PROJECTS: Columbia Pike (US 29) at Briggs Chaney Road
Mandatory Referral No. 02802-SHA-1

REVIEW TYPE: Mandatory Referral

RECOMMENDATION: APPROVAL WITH COMMENTS TO SHA

Thank you for your comments on the semi-final review plans for the US 29 at Briggs Chaney Road project. These plans were only complete to semifinal design. Therefore, not all cross walk locations had been identified. These details are being finalized now. Listed below are your comments with responses shown in bold.

ATTACHMENT 2

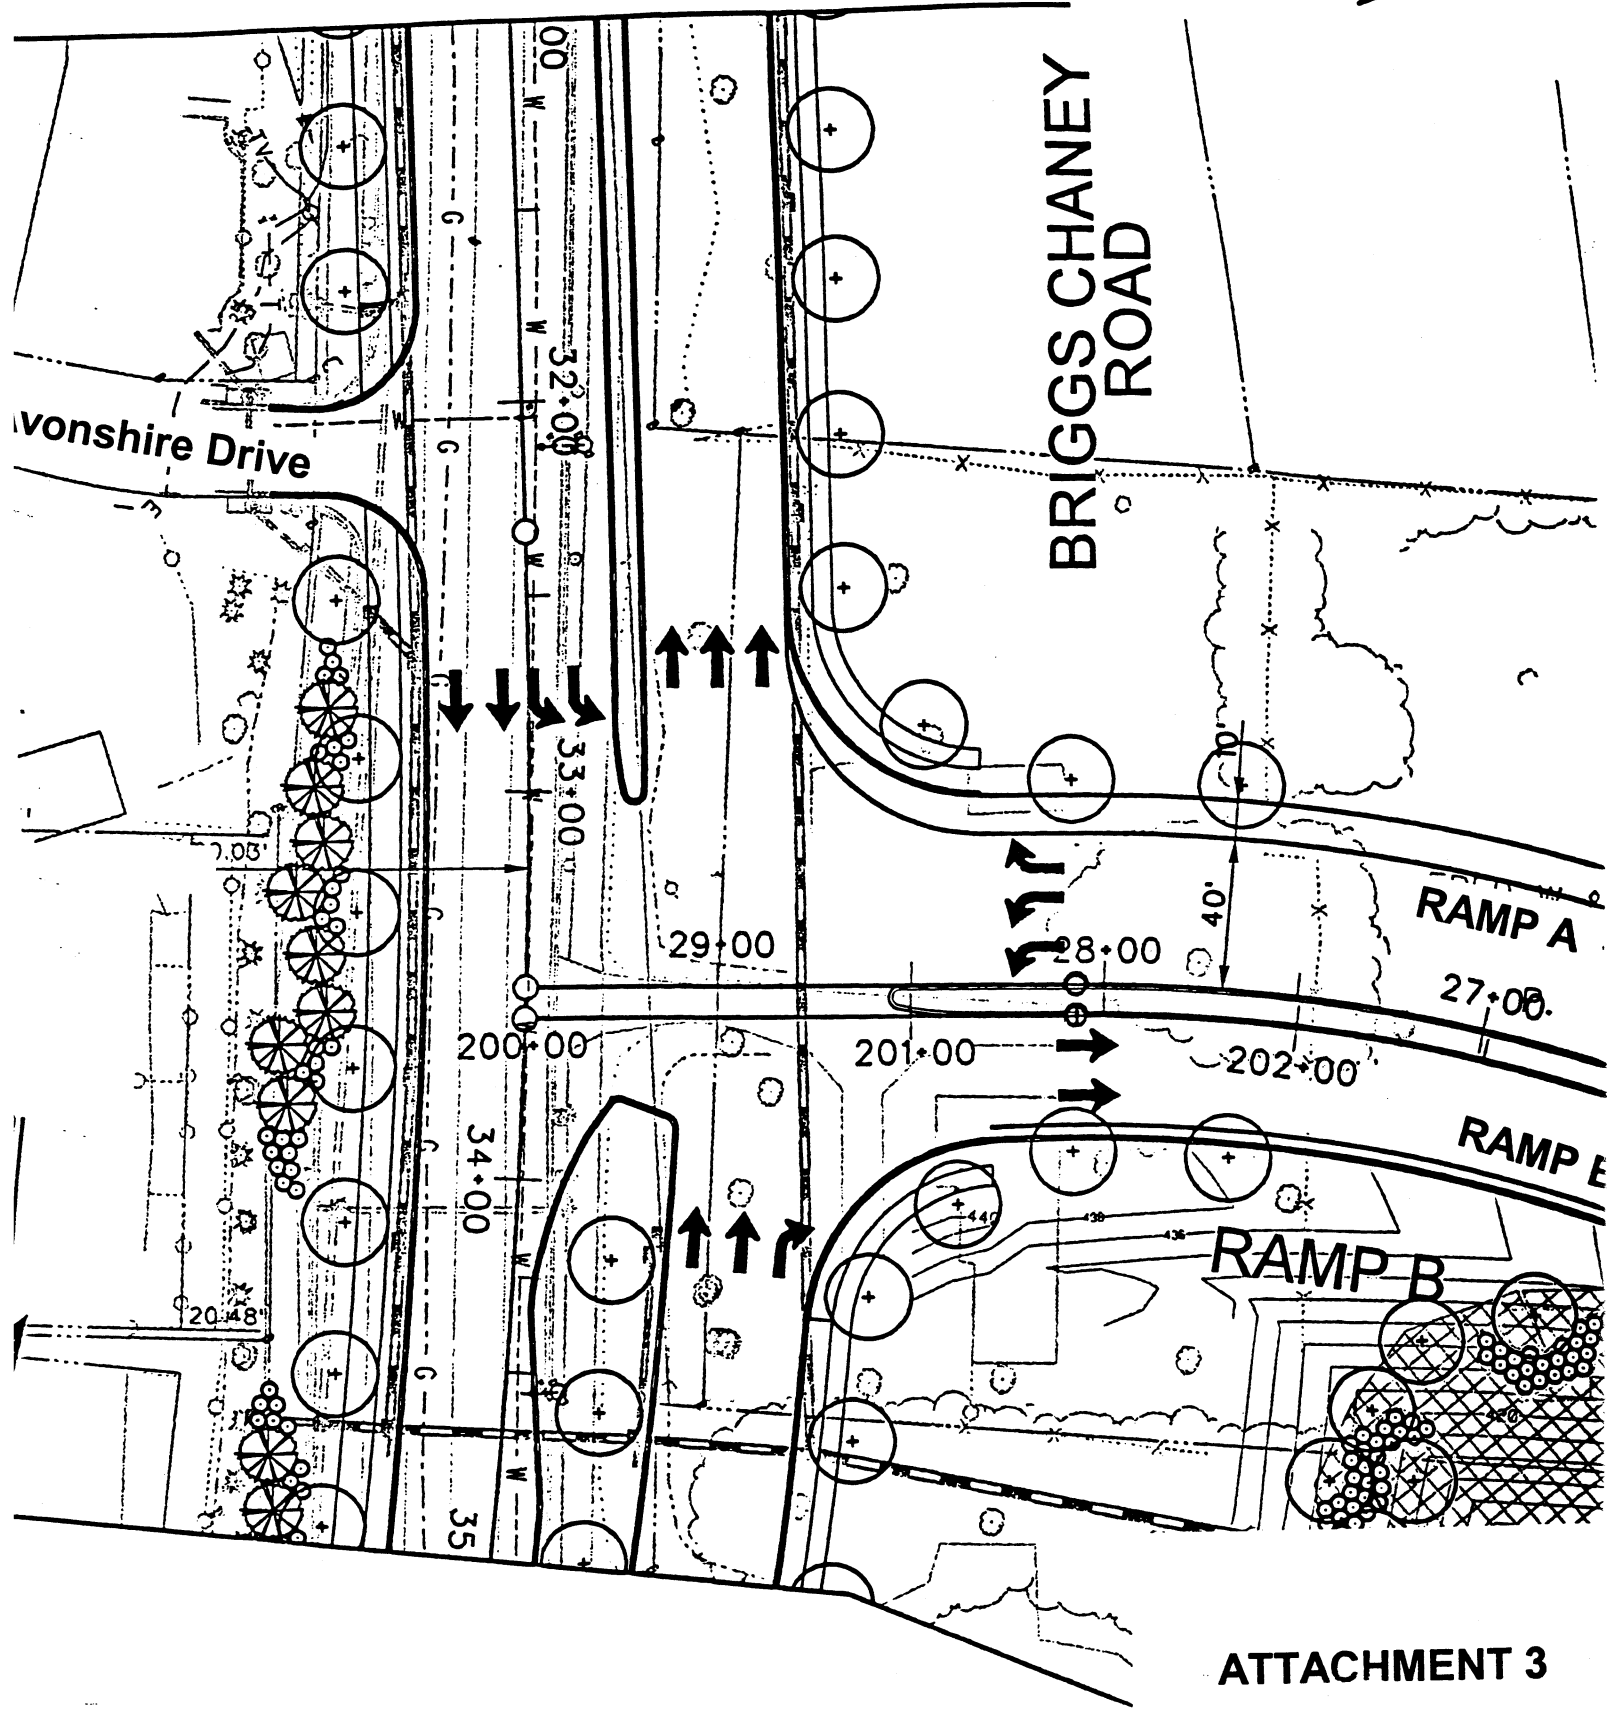
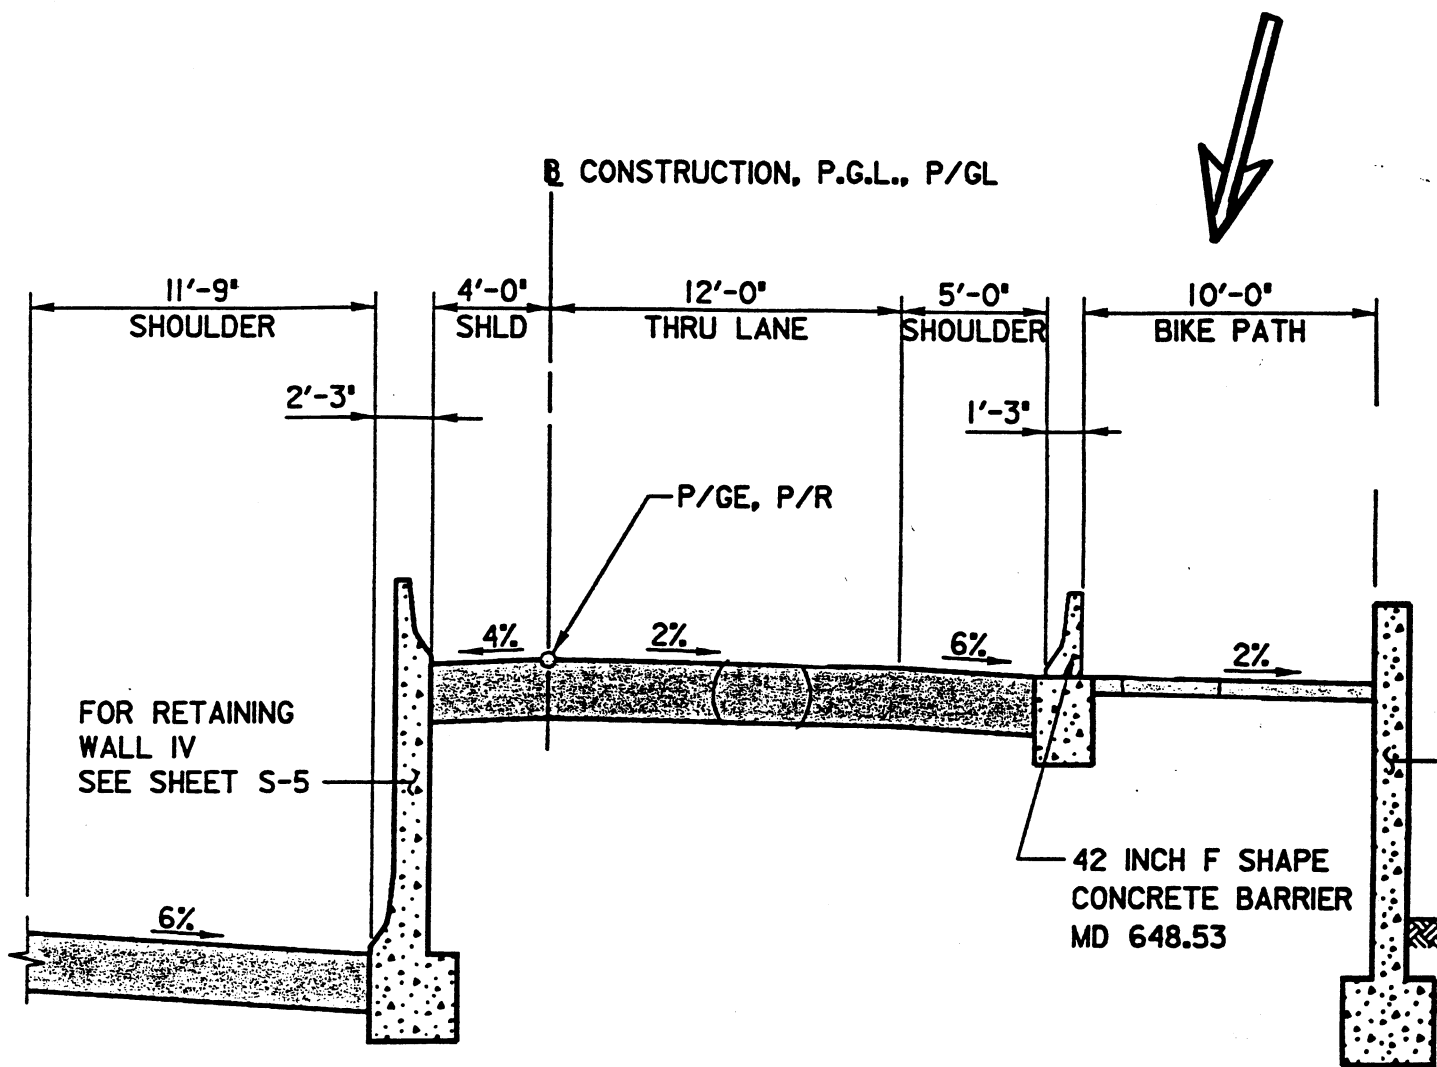
3. Enlarge the island at Ramp C and Briggs Chaney Road and extend the median on Briggs Chaney Road at this location to provide a refuge to accommodate bicyclists waiting to cross these roads.
4. Evaluate the proposed lighting along Briggs Chaney Road east of US 29 and provide additional fixtures as necessary.
5. Create a follow-up project to complete the median priority bus lanes between the US 29/New Hampshire Avenue (MD 650) interchange and the Howard County line and the commuter bikeway between Tech Road and Spencerville Road (MD 198) consistent with the Planning Board's previous recommendations.
6. Reconstruct and replace in kind all landscaping located in:
 - The buffer along the frontage of Montgomery Auto Sales Park;
 - The Avonshire development; and
 - The AutoPark

The traffic island at the top of Ramp C is the crossing point for the US 29 Commuter Bikeway and the bikeway along the south side of Briggs Chaney Road (see Attachment 2). ***Staff recommends that this island be enlarged and that the median on Briggs Chaney Road be extended to provide a refuge to accommodate bicyclists waiting to cross these roads.***

Staff recommends enlarging traffic island and extending median

The pork-chop island at the terminus of Ramp-C will be widened from the current size of 225sf to maximum size, which does not affect turning movements.
